SUBJECT: Verification of the NOV 21, 1979
Auxiliary Feed pumps Net Positive
Suction head Available.

E/C IDENTIFICATION NO: HXP791121A REVISION NO. 4

HXP791121AF - Verification of the Nov 21, 1979 Auxiliary Feed Pumps Net Positive
Suction Head Available

880 RPM
 BOWL - CAST IRON
 COATED
 CURVE SHEET NO.
EC-2558

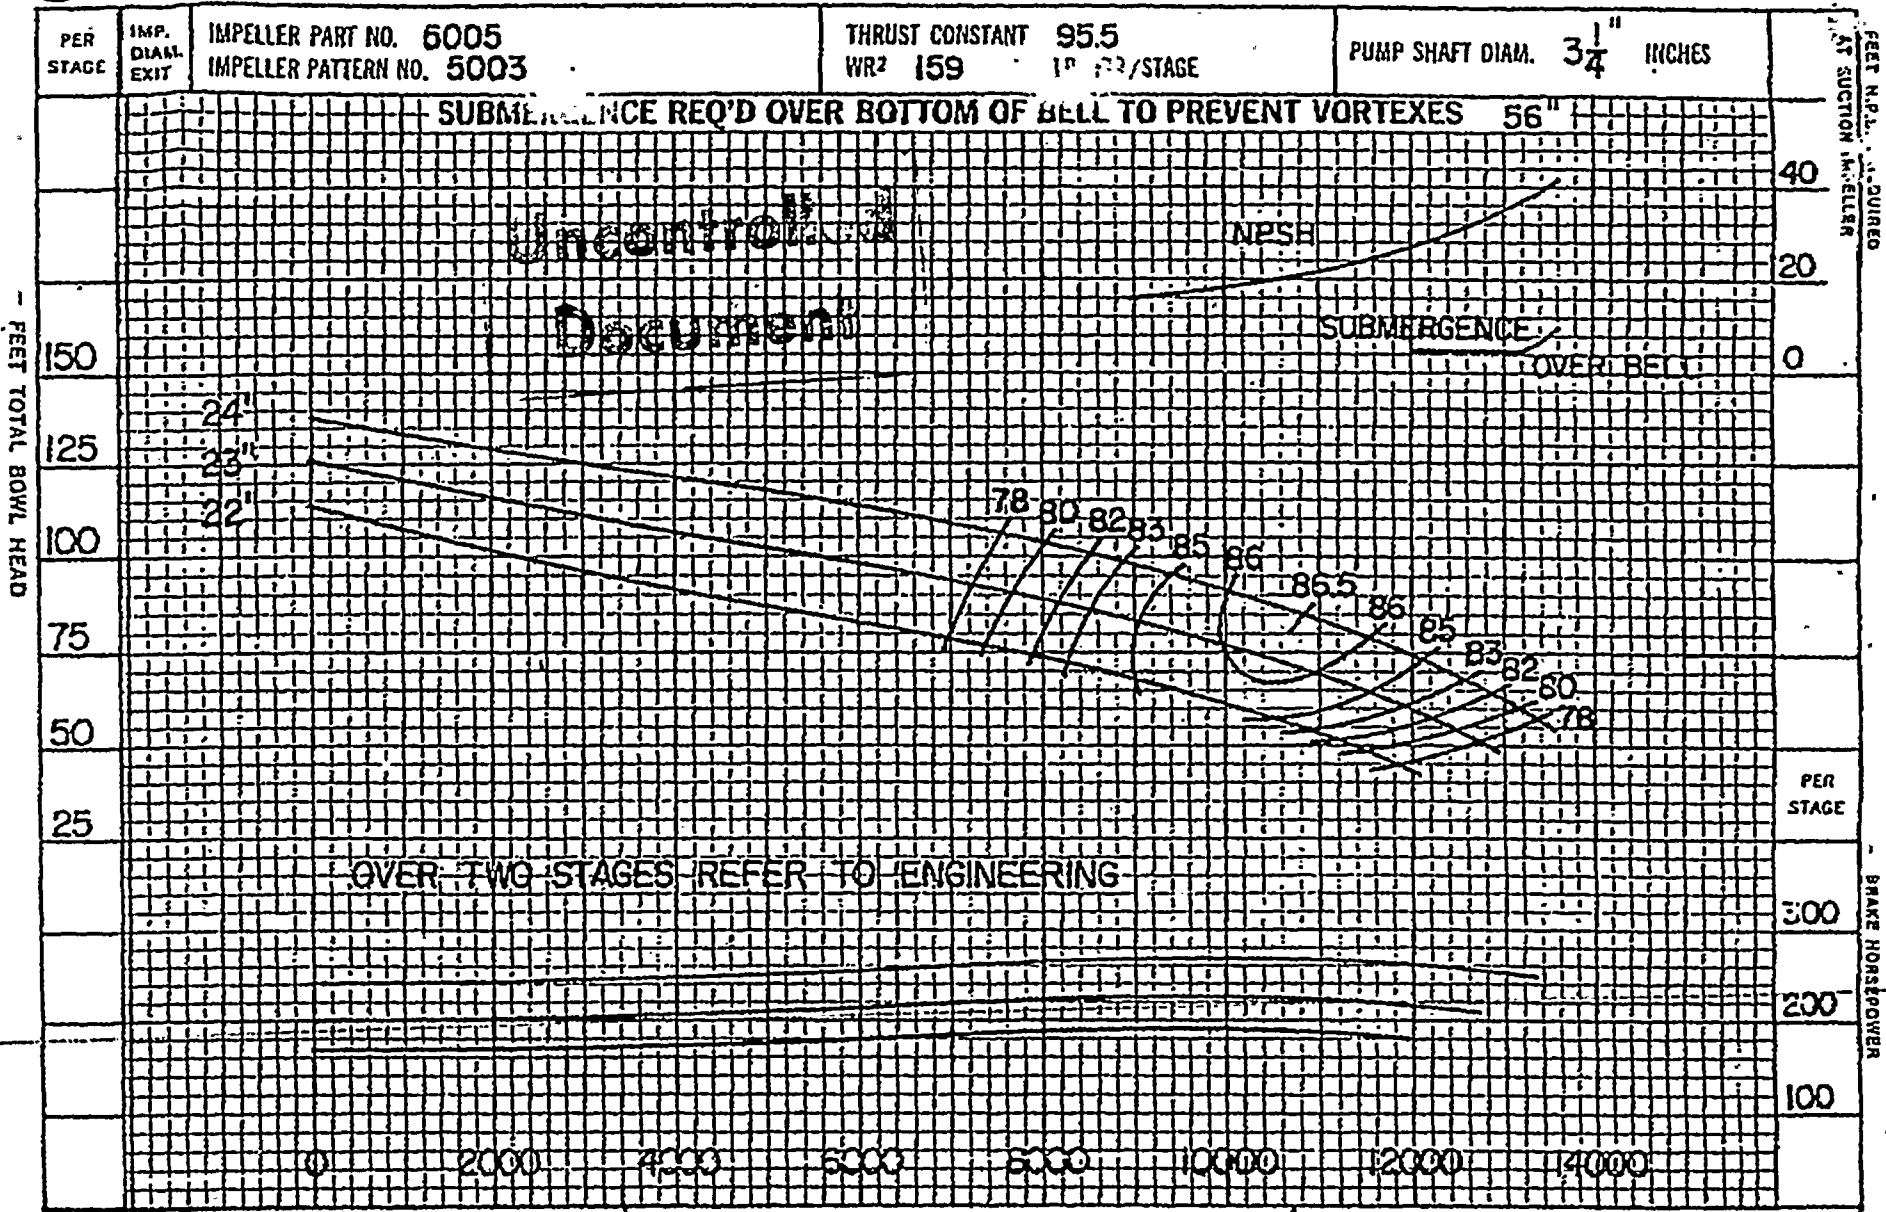
* Joe Lula to revise the review to indicate that the calculation should show that pump operation is limited by flow retention and operation will not occur in the extrapolated portion of the NPSHr curve. Additionally, the extrapolated curve should be deleted from the calculation. Resolved - Calculation does not use extrapolated data. (JL 3/20/98)

<u>Comment Rating</u>	<u>Comment Text</u>
A1	Design inputs have not been identified within the calculation. No clear reference was provided for the NPSHr curves.
